ST/SG/AC.10/19/Add.1
16 February 1993

REPORT OF THE COMMITTEE OF EXPERTS ON ITS SEVENTEENTH SESSION

Addendum 1

Annex 1: Amendments to Chapters 1, 4, 5, 6 (Division 6.1 only), 8, 11, 14 and 15 of the Recommendations on the Transport of Dangerous Goods.

Figure 5.1 - Combustibility tester

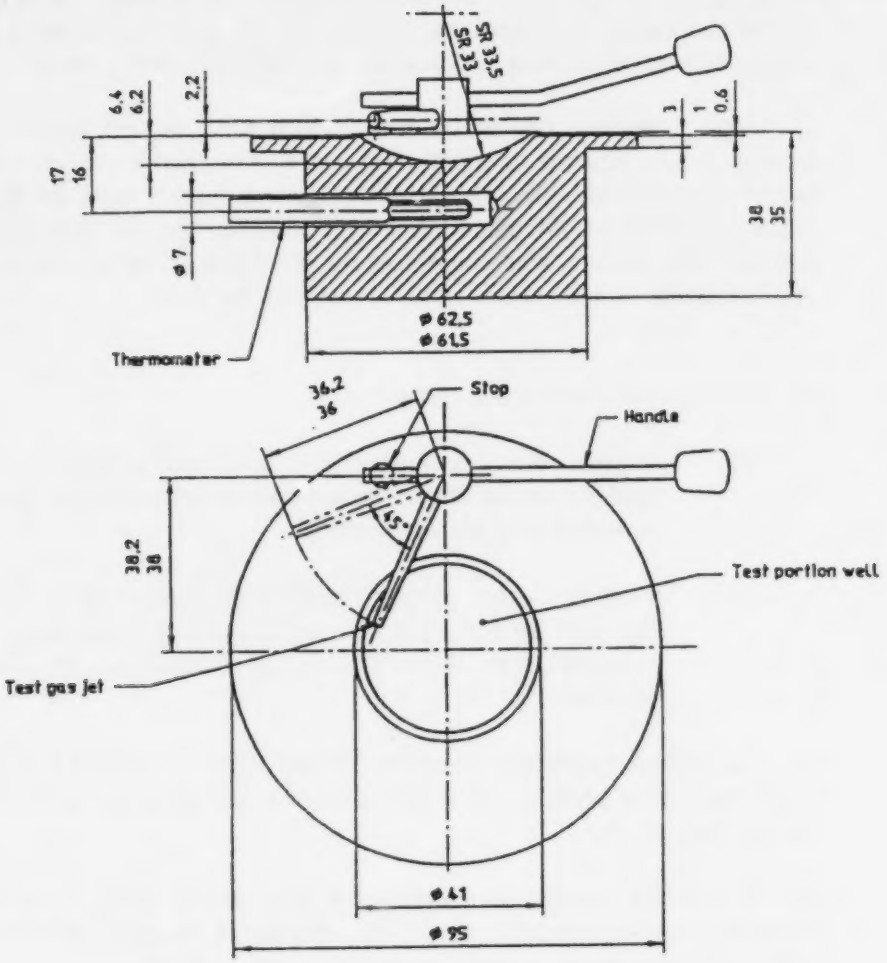
After 5.6.1 (c), add a new heading and a new section 5.7 as follows:

5.7.2 Apparatus: A combustibility tester consisting of a block of aluminium alloy or other corrosion-resistant metal of high thermal conductivity is used. The block has a concave well and a pocket drilled to take a thermometer. A small gas jet assembly on a swivel is attached to the block. The handle and gas inlet for the gas jet may be fitted at any convenient angle to the gas jet. A suitable apparatus is shown in Figure 5.1 and the essential dimensions are given in Figures 5.1 and 5.2. The following equipment is needed:

(a) *Gauge*, for checking that the height of the centre of the gas jet above the top of the test portion well is 2.2 mm (see Figure 5.1);

Figure 5.2 - Test gas jet and flame

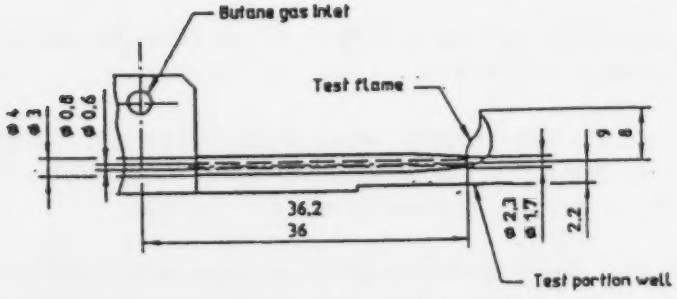
(c) Light the butane test fuel with the jet away from the test position (i.e. in the "off" position, away from the well). Adjust the size of the flame so that it is 8 mm to 9 mm high and approximately 5 mm wide.
